Access Compliance Report Public Rights-of-Way (Curb Ramps)

Main Street: TIFFANY_PL Cross Street: CHAPLET_PL Location: N

ADA ID: RPRK220103153835 Ramp Type: Type 4 - Parallel Initial Pass/Fail: Pass Overall Compliance: No Severity Score: 0

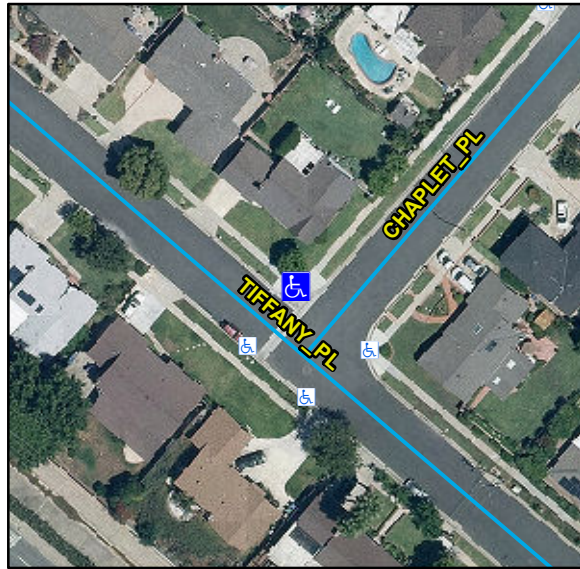
Surveyor Notes:

N/A

Possible Solutions:

Remove & Replace Curb Ramp With Two New Directional Ramps or Equivalent.
